2nd Revised Response to Request for Additional
Information No. 841-6055 Revision 3

US-APWR Design Certification

RAI NO.: NO. 841-6055 REVISION 3
SRP SECTION: 03.04.01 – INTERNAL FLOOD PROTECTION FOR ONSITE EQUIPMENT FAILURES
APPLICATION SECTION: 3.04.01
DATE OF RAI ISSUE: 10/18/2011

QUESTION NO.: 03.04.01-29:

Figure 3E-3 Chemical and Volume Control System Flow Diagram (1/4)

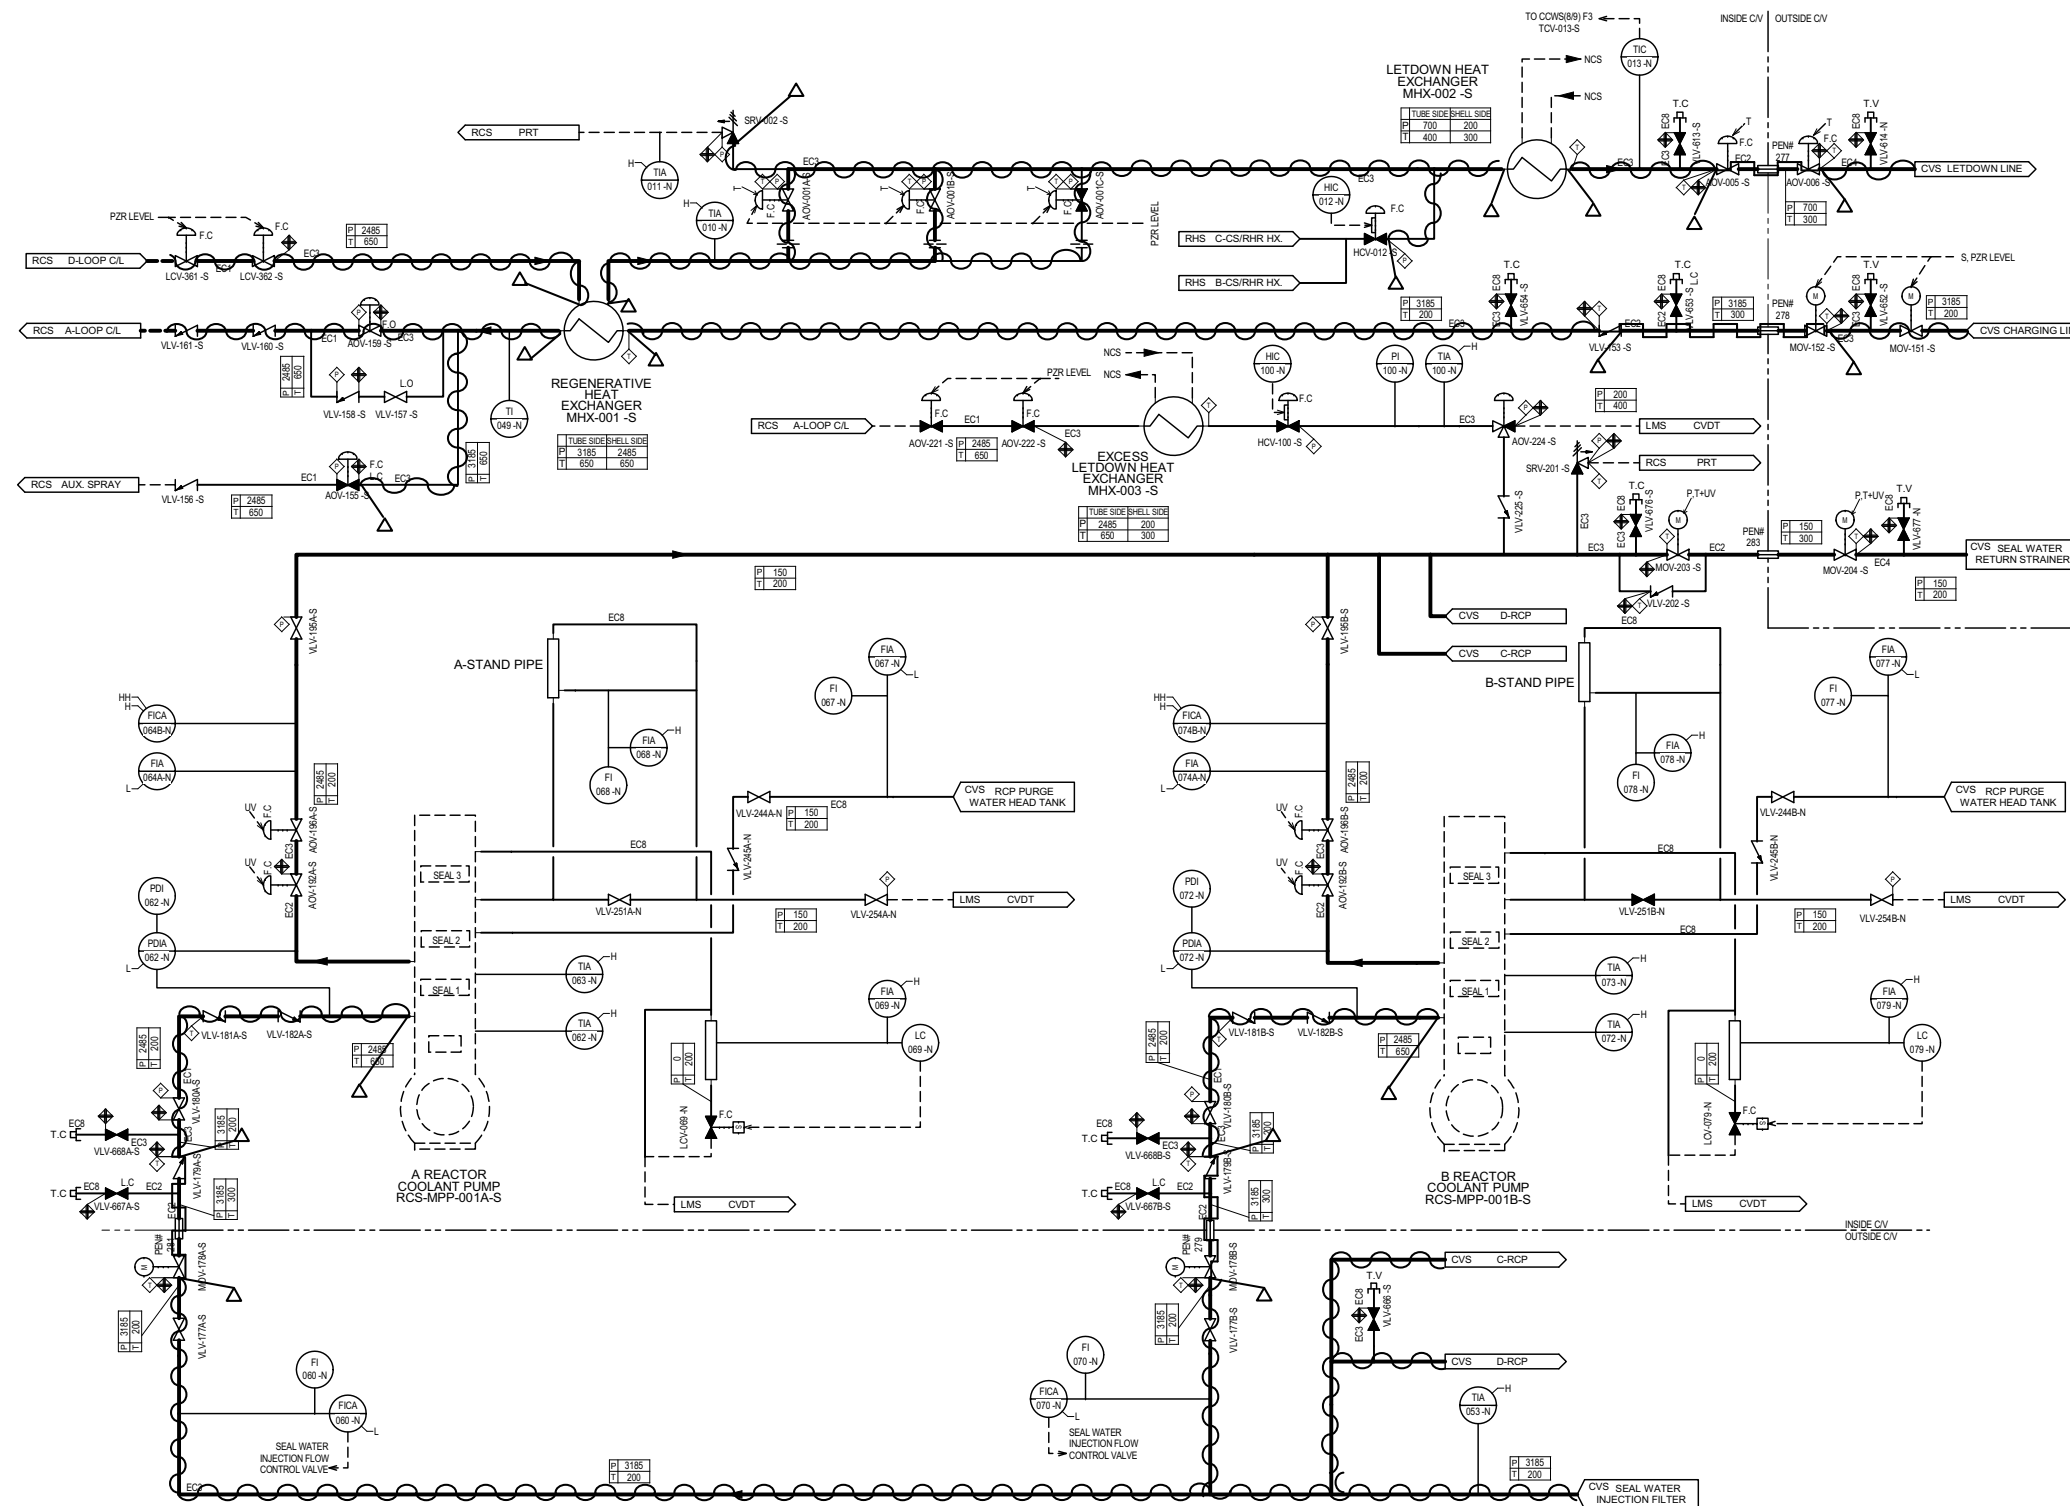
The following portions of the DCD are revised to reflect the updated equipment class and seismic category of water-containing piping on which the flooding evaluation is based.

Tier 2	Chapter 3	Section 3.2.2, Section 3.4.1, Figure 3E-2, Figure 3E-6,	Table 3.2-2, Figure 3E-3, Figure 3E-9	Figure 3E-5,
	Chapter 5	Figure 5.1-2		
	Chapter 9	Figure 9.1.3-2, Section 9.2.2, Figure 9.2.6-2, Section 9.2.7, Figure 9.3.2-1, Figure 9.3.4-1, Section 9.5.1	Figure 9.2.2-1, Figure 9.2.6-3, Figure 9.2.7-2,	
	Chapter 10	Figure 10.4.9-2
